SITE SUPPLEMENTAL INSTRUCTION

PROJECT: Forestside Estates
Attmar & Palleschi Drive
Brampton, ON

SITE SI NO. M-4

PURPOSE: To revise mechanical layout to suit Arch change and reply city plumbing comments.

DRAWN	CHECKED	SCALE
MC	LM	1:50
DATE	PROJECT	DRAWING
MAY, 2019	18-017	M-26
		OF -

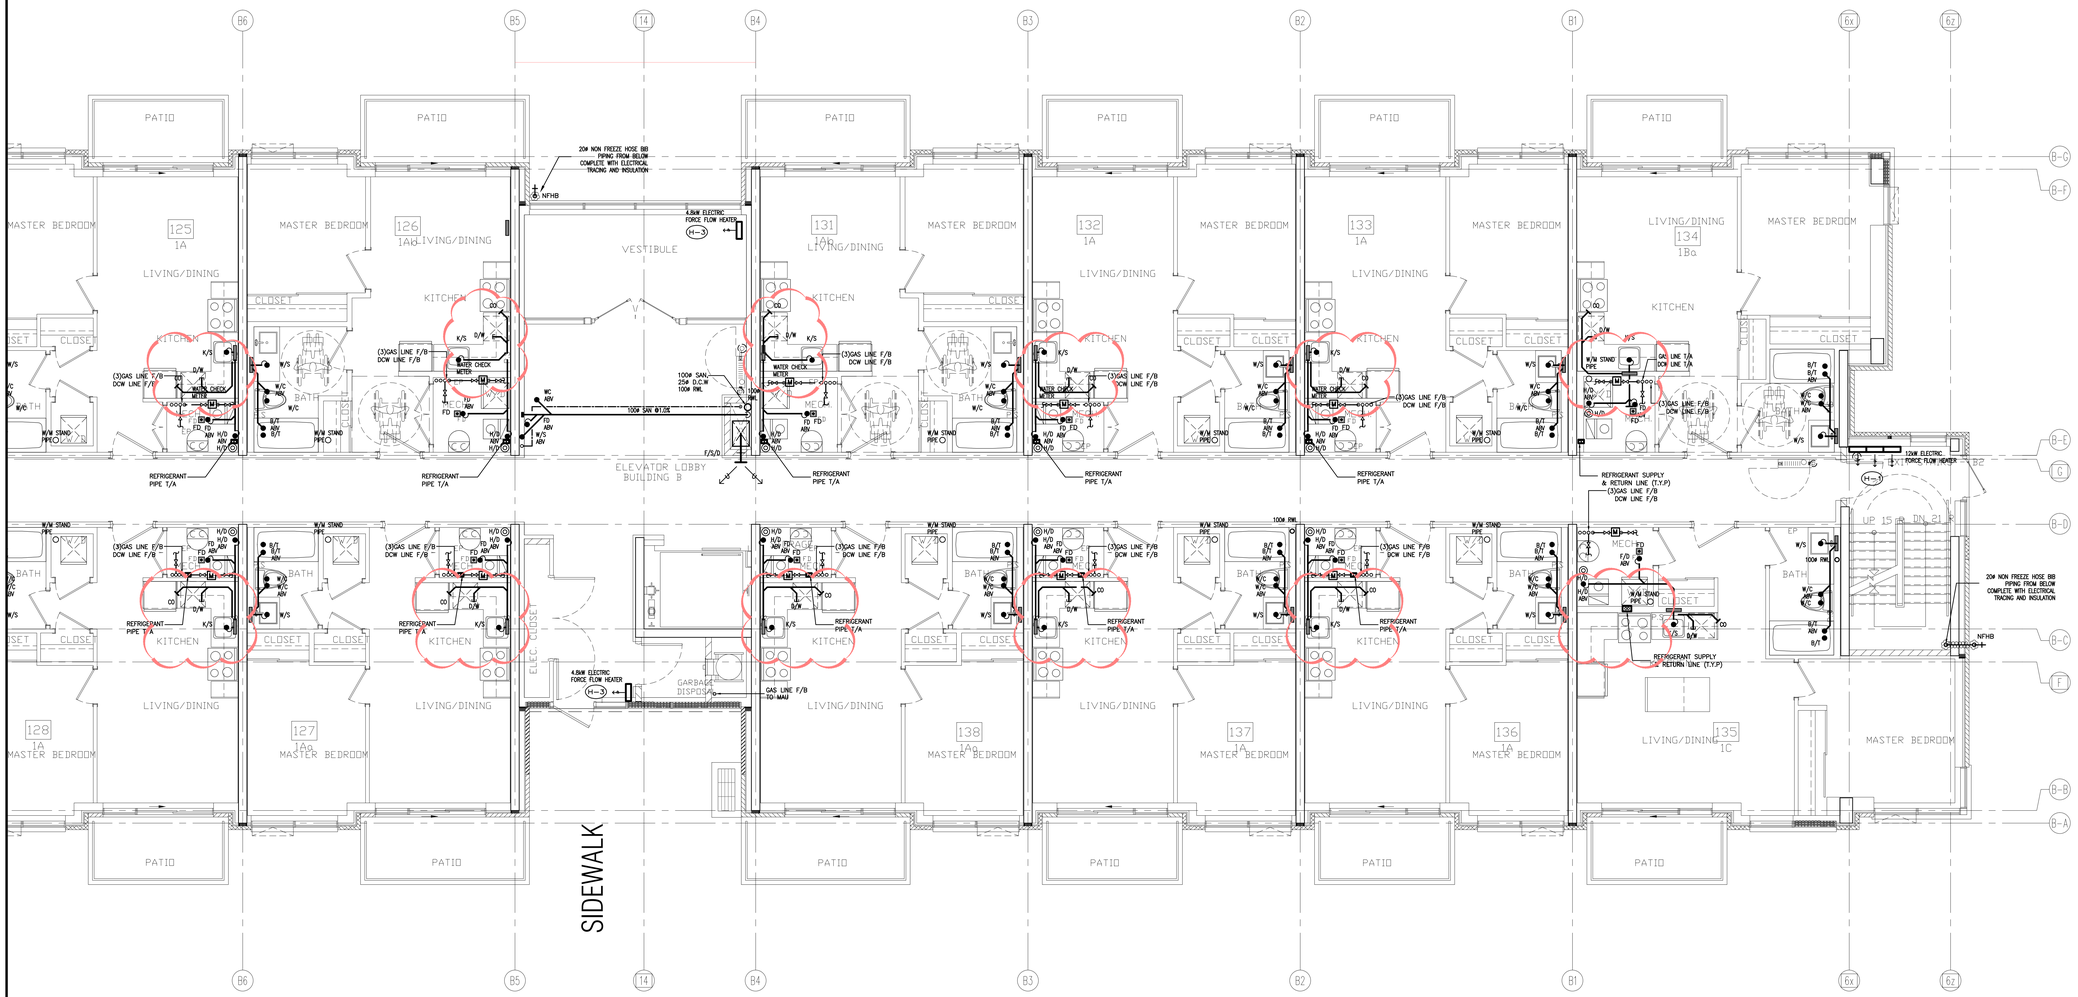
4.0 Reference Drawing M-25-M-34 (Building B - Mechanical) Issued

4.1 Showed: Kitchen dishwasher and clean out for suite type 1C, 1A, 1Aa, 1Ab, 1Ba.

4.2 Added: 2 hour fire rate ceiling for plumbing at 3rd floor stair.

4.3 Added: Roof drain for 3rd floor roof and picked up below.

4.4 Clarify: Location and numbers of scupper drains at roof.

4.5 Revised: Suite# 228,229,236,237 gas and DCW line location.

4.6 Revised: Suite# 328,329,336,337 Mechanical room layout.

DRAWN	CHECKED	SCALE
MC	LM	1:50
DATE	PROJECT	DRAWING
MAY, 2019	18-017	M-35
		OF -

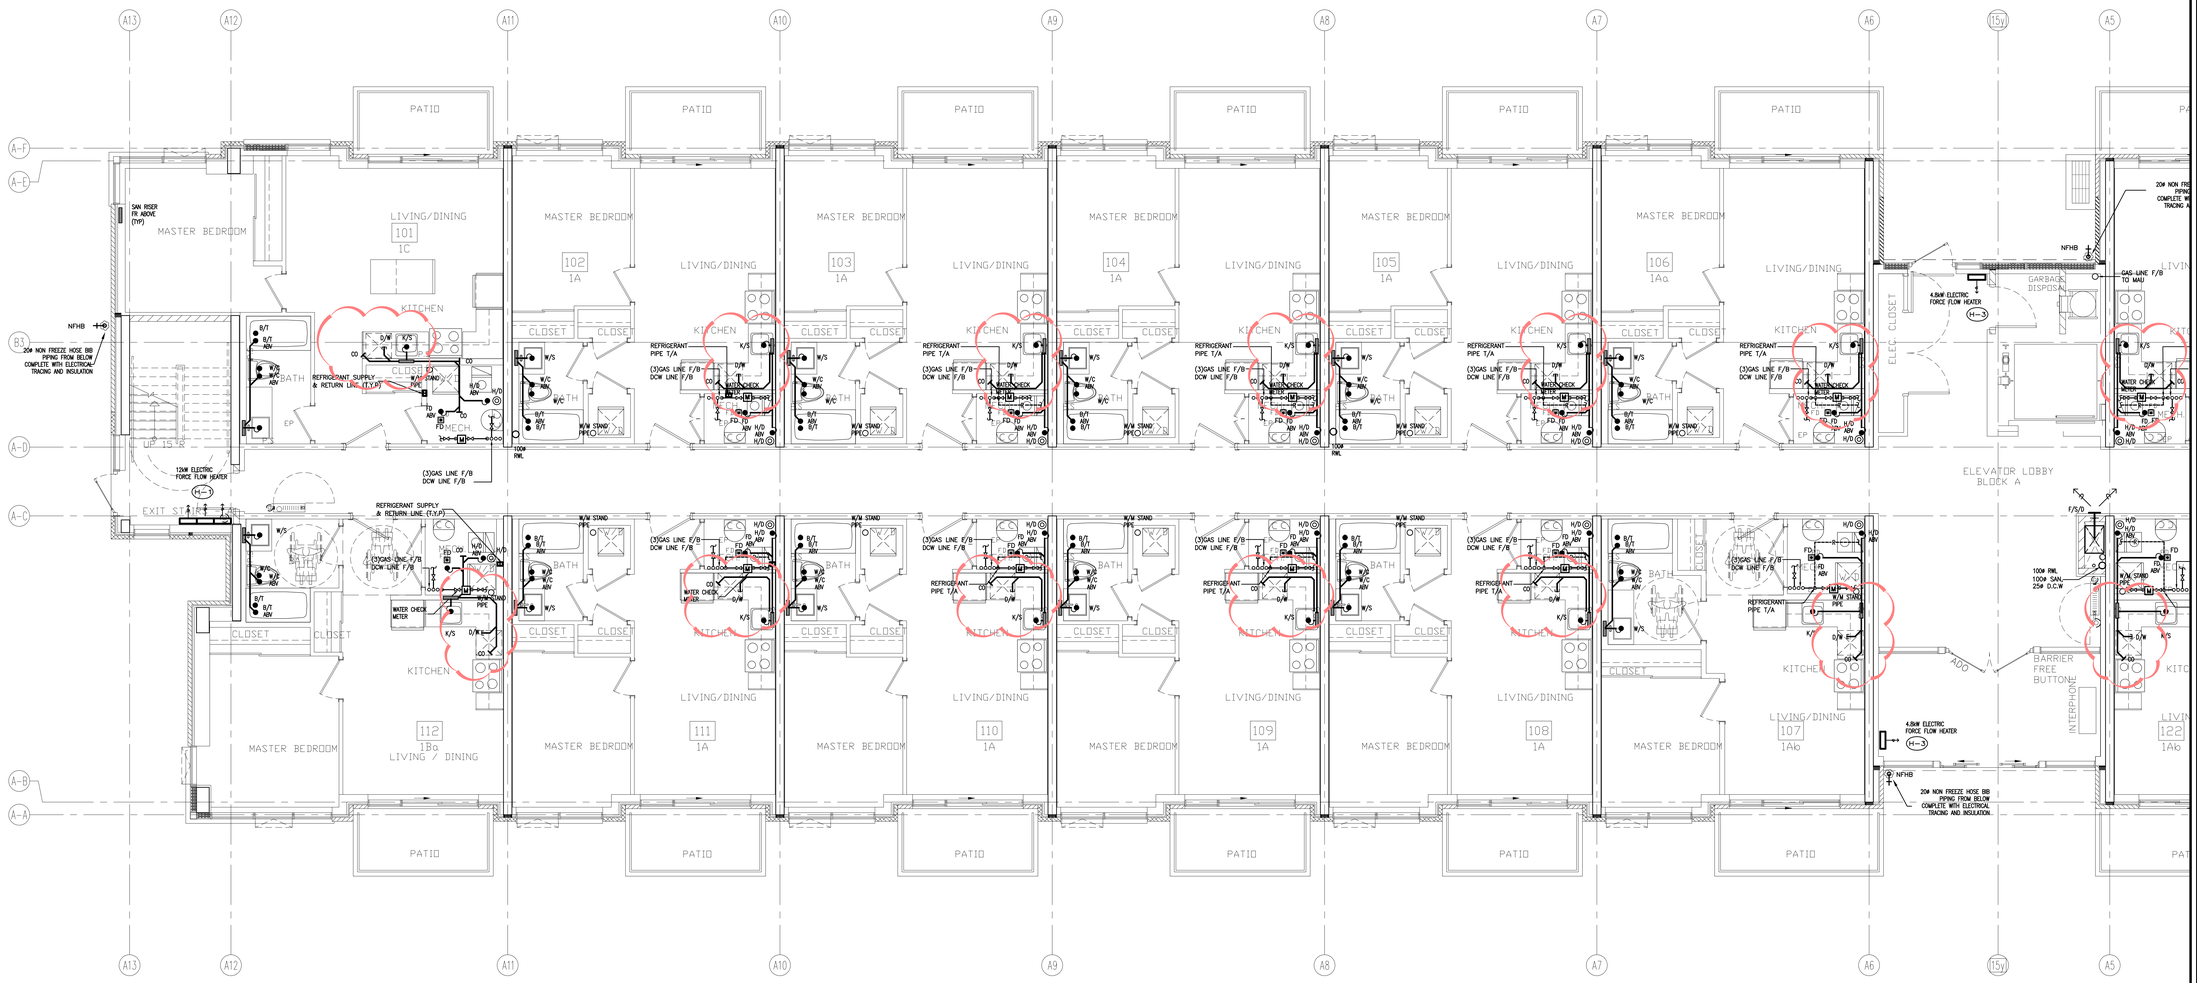
5.0 Reference Drawing M-35-M-44 (Building A - Mechanical) Issued

5.2 Added: 2 hour fire rate ceiling for plumbing at 3rd floor stair.

5.3 Added: Roof drain for 3rd floor roof and picked up below.

5.4 Clarify: Location and numbers of scupper drains at roof.

5.5 Revised: Suite# 202,203,204,205,214,215,216 gas and DCW line location.

5.6 Revised: Suite# 302,303,304,305,314,315,316 Mechanical room layout.
